Permit # \_\_\_\_\_ City of Portland BUILDING PERMIT APPLICATION Fee \$25. Zone \_\_\_\_\_ Map # \_\_\_\_\_ Lot# \_\_\_\_\_

Owner: Gotta Dance Inc Phone # 773-3553  
 Address: Thompson's Pt; Bldg A - 2nd Fl. 04102  
 LOCATION OF CONSTRUCTION Thompson's Point - Bldg A  
(2nd floor)  
 Contractor: owner Sub.: \_\_\_\_\_  
 Address: \_\_\_\_\_ Phone # \_\_\_\_\_  
 Est. Construction Cost: \_\_\_\_\_ Proposed Use: Dance Hall  
 Past Use: vacant space  
 # of Existing Res. Units \_\_\_\_\_ # of New Res. Units \_\_\_\_\_  
 Building Dimensions L \_\_\_\_\_ W \_\_\_\_\_ Total Sq. Ft. \_\_\_\_\_  
 # Stories: \_\_\_\_\_ # Bedrooms \_\_\_\_\_ Lot Size: \_\_\_\_\_  
 Is Proposed Use: Seasonal \_\_\_\_\_ Condominium \_\_\_\_\_ Conversion \_\_\_\_\_  
 Explain Conversion Change of Use - from vacant space

Re: Building A, Thompson's Point

Your application for change of use - vacant space to dance hall - has been reviewed and a permit is herewith issued subject to the following requirements:

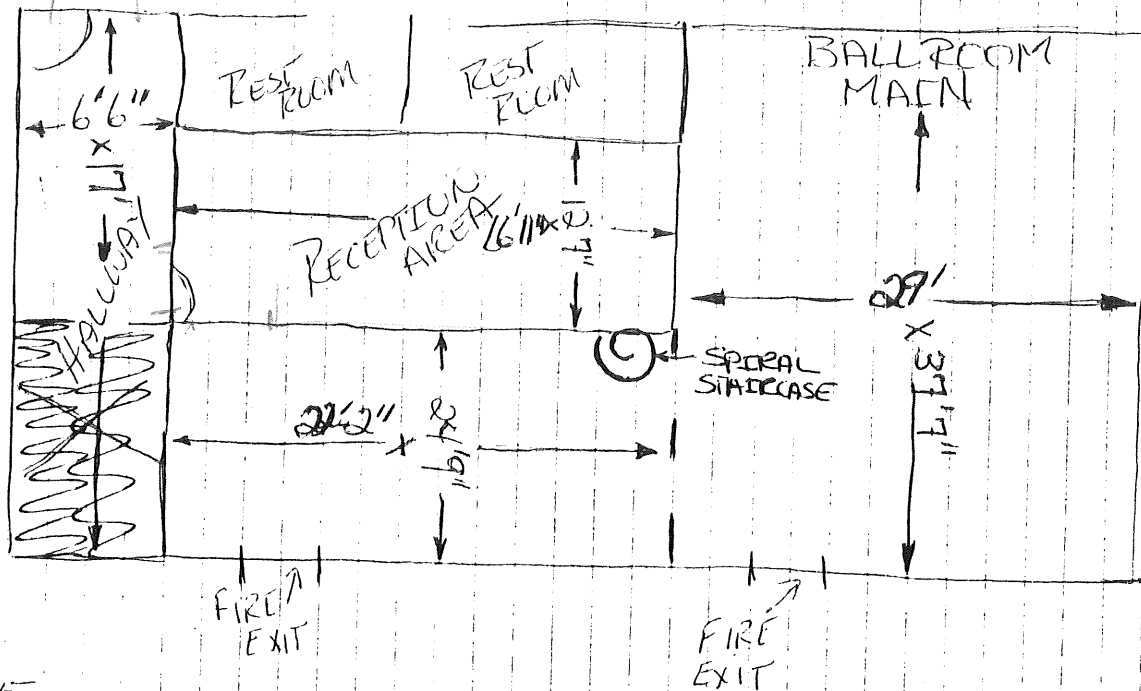
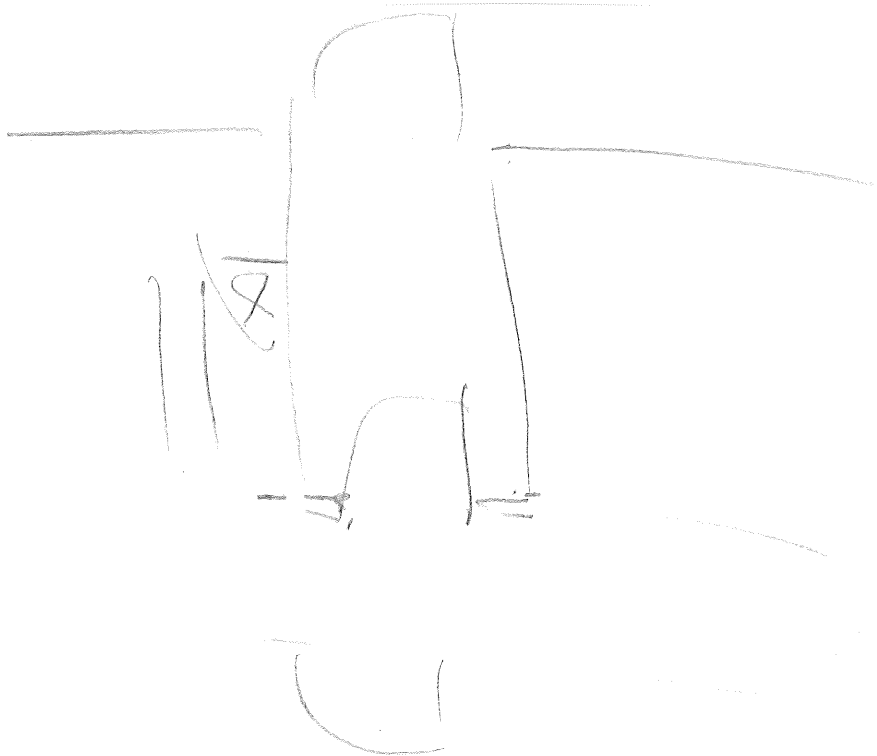
1. Vertical openings shall be protected by 1 hr. fire resistance construction and openings therein protected by 1 hr. fire protection rated self-closing fire doors. Ref. Section 6-2 of N.F.P.A. 101 Life Safety Code and Section 5-2.1.
2. The fire escape stairs shall be in accordance with Section 5-2.8.
3. Separation from areas of hazard shall be in accordance with 8-3.2.3.
4. Emergency lighting and egress marking shall be in accordance with Section 5-9 and 5-10.
5. The 2nd floor or Mezzanine area may not be used for public access due to the lack of a second means of egress.
